ADDENDUM NO. 2

RE: Item #8, October 7, 2026 Letting - IM 0292(100)55, PCN 09TY, Lincoln County - Construct Median & Ramp Crossovers

PROJECT	SECTION	SHEET
IM 0292(100)55	F	10/32

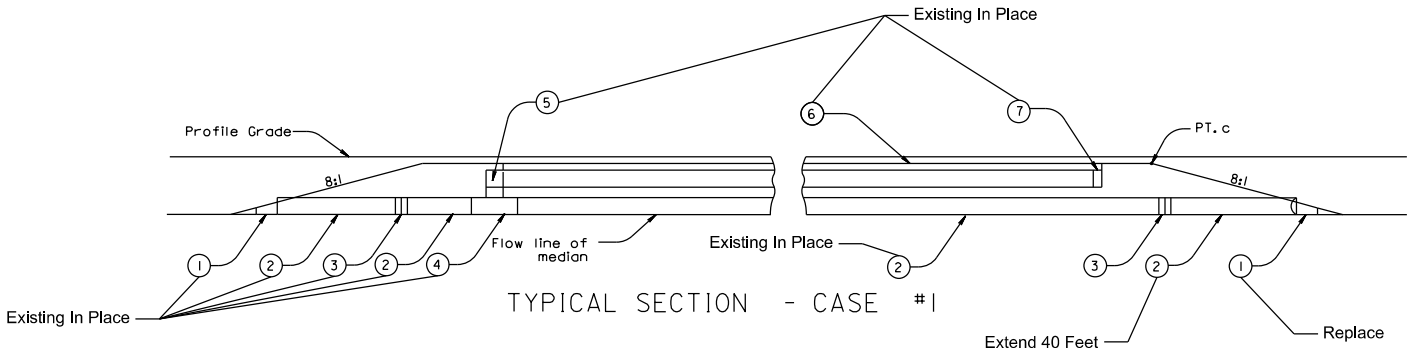
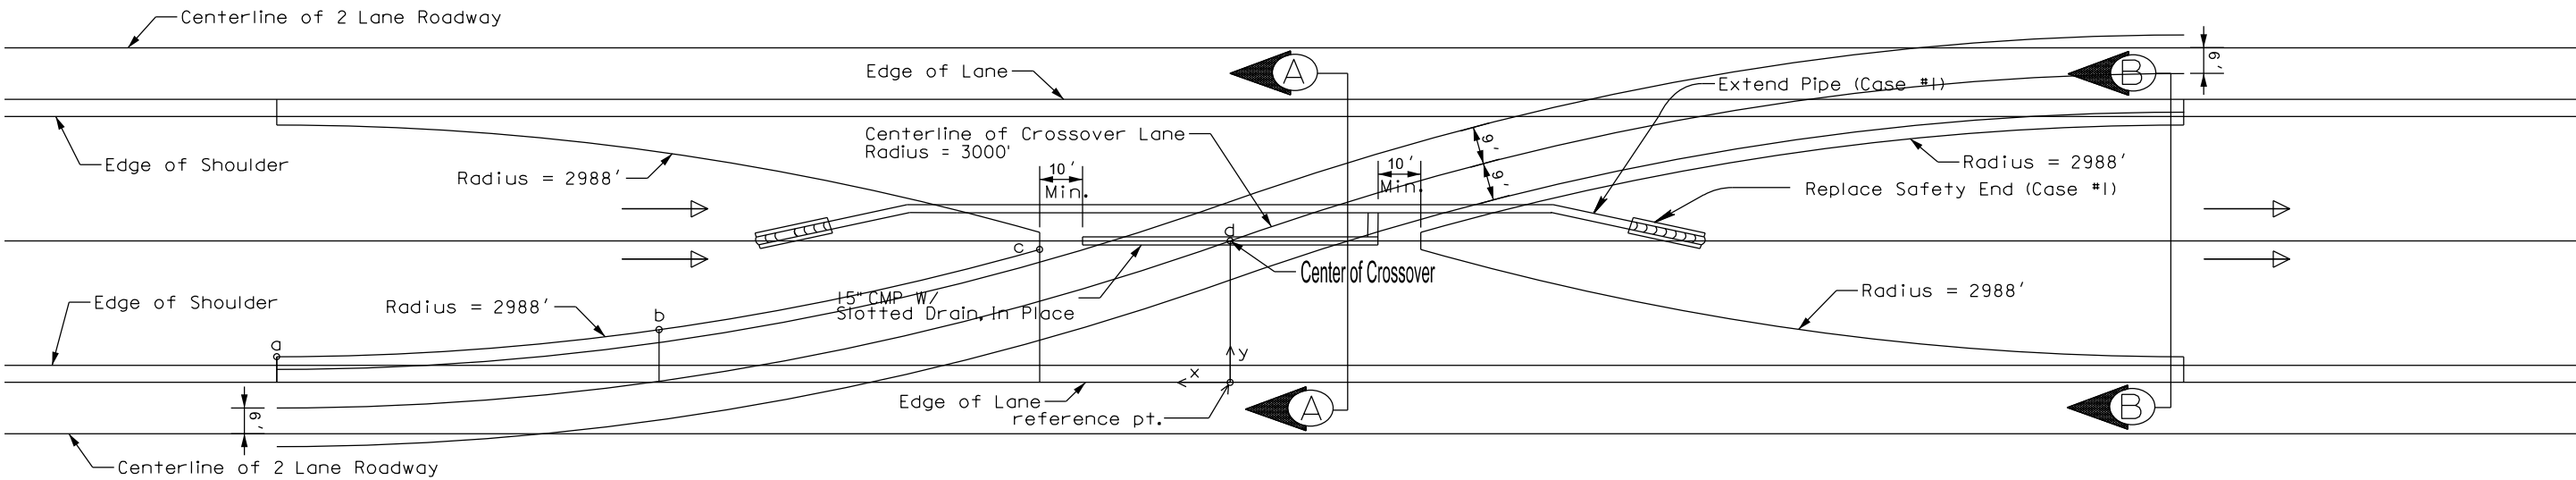
Sheets F10, F14, F18 & F22: Median Drainage Components were revised to include estimated quantities.

- ① 15" CMP Safety End (1)
- ② 15" CMP (40')
- ③ 15" CMP 15° Elbow
- ④ 15" x 15" x 15" CMP Tee
- ⑤ 15" CMP 90° Elbow
- ⑥ 15" CMP Slotted Drain
- ⑦ 15" CMP Cap

PROJECT	SECTION	SHEET
IM 0292(100)55	F	11/32

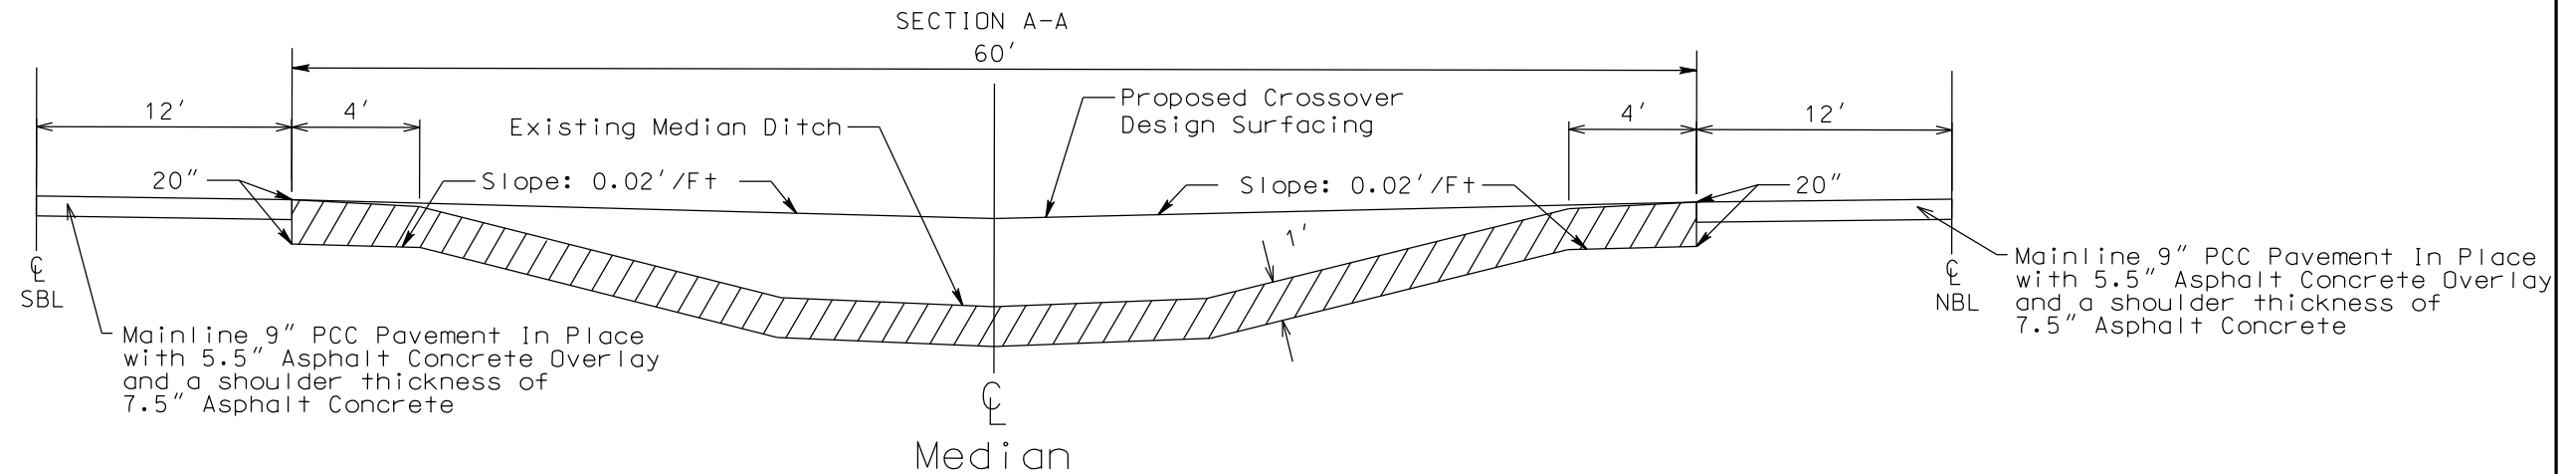
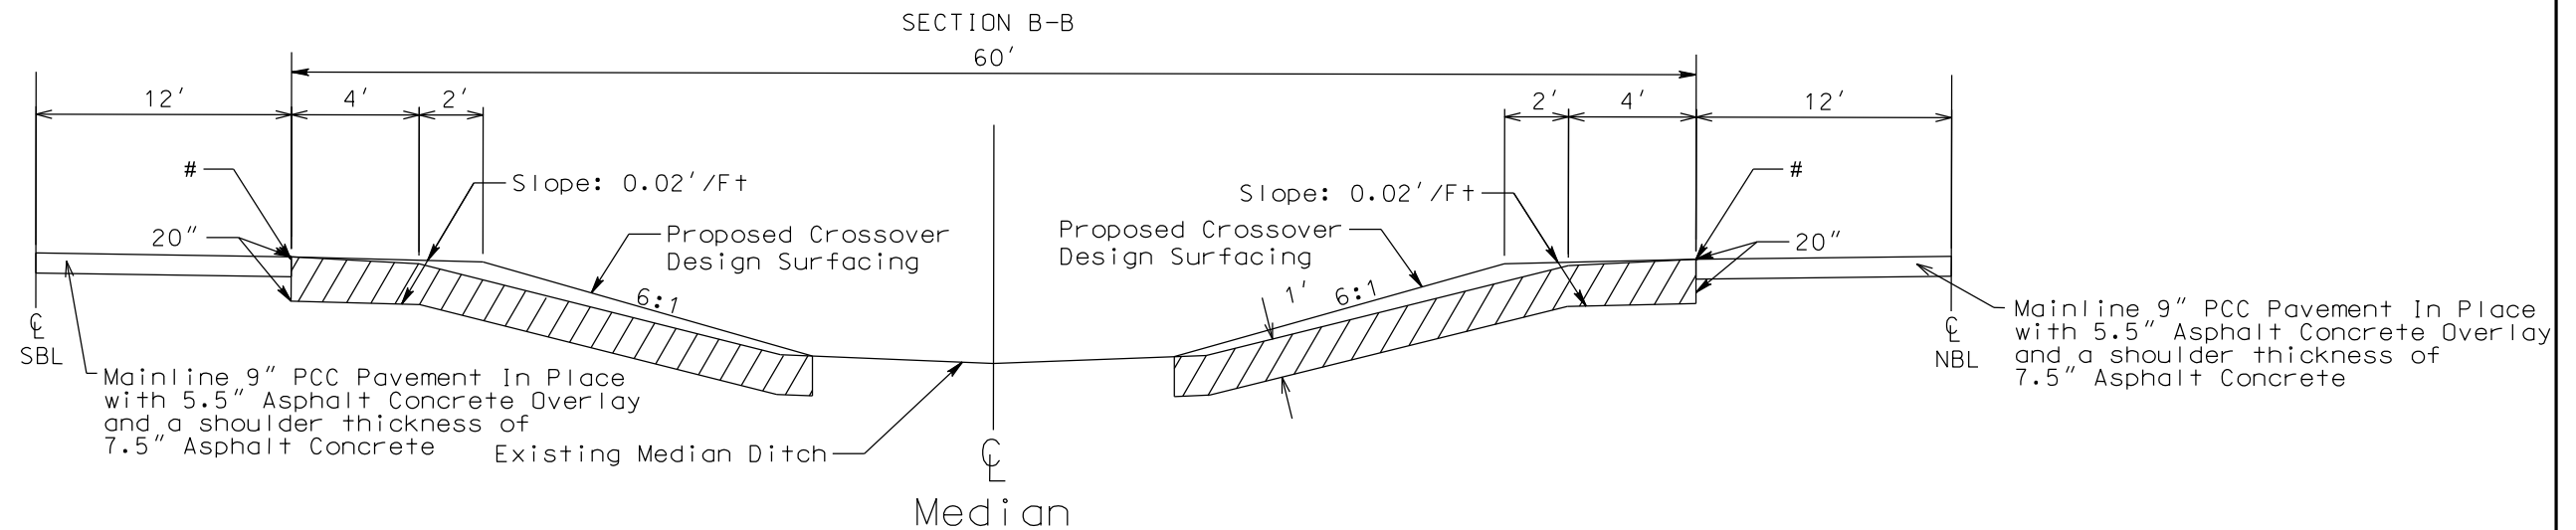
Sheets F11-F12, F15-F16, F19-F20 & F23-F24: Median Crossover existing mainline surfacing notes on typical sections were revised.
